RE: Manzanita Lofts Transportation Impacts

Greenlight Engineering has been asked by Concerned Citizens of Manzanita to evaluate the transportation related impacts of the proposed Manzanita Lofts development in Manzanita, Oregon.

We have reviewed the applicant's April 7, 2022 Manzanita Lofts PUD Traffic Analysis (hereafter referred to as the "Traffic Analysis"), the May 6, 2022 Lancaster Mobley letter ("Mobley letter"), the May 26, 2022 site plan and the May 9, 2022 staff report.

Figure 4.3 of City of Manzanita Downtown Transportation Plan, Classic Street Cross Section

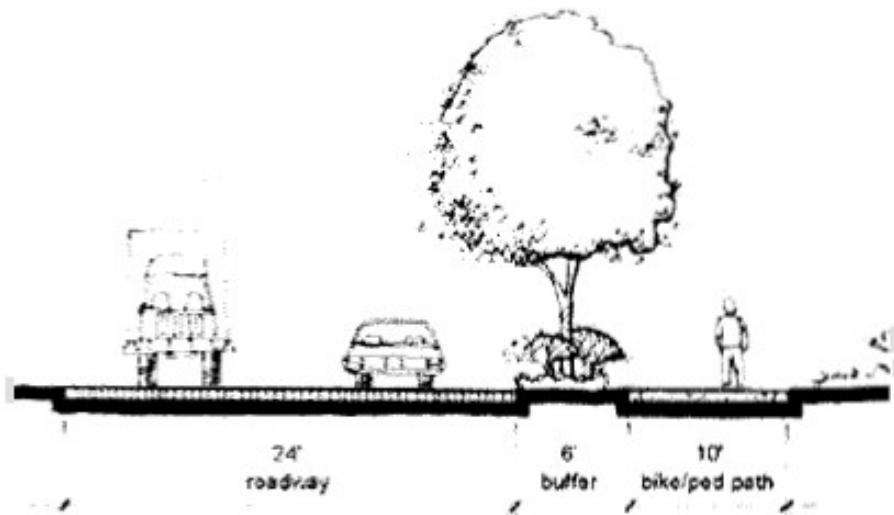
shared bicycle/pedestrian path." The development's Classic Street frontage is not compliant with this adopted roadway cross section. The applicant's Traffic Analysis notes that the street is just 21-22 feet in width and with separated bike or pedestrian facilities.

It is common to require development to improve its own roadway frontage to be compliant with jurisdictional cross section standards when a site develops with an increase in traffic generation. This development certainly increases the traffic generation of the site and is anticipated to generate up to 309 daily vehicles.

The City of Manzanita Downtown Transportation Plan adopted a Classic Street cross section from Laneda Avenue to Necarney City Road which includes “A 40-foot-wide right-of-way. Two 12-foot-wide travel lanes (24-foot-wide roadway), 6-foot-wide landscaped buffer and 10-foot-wide
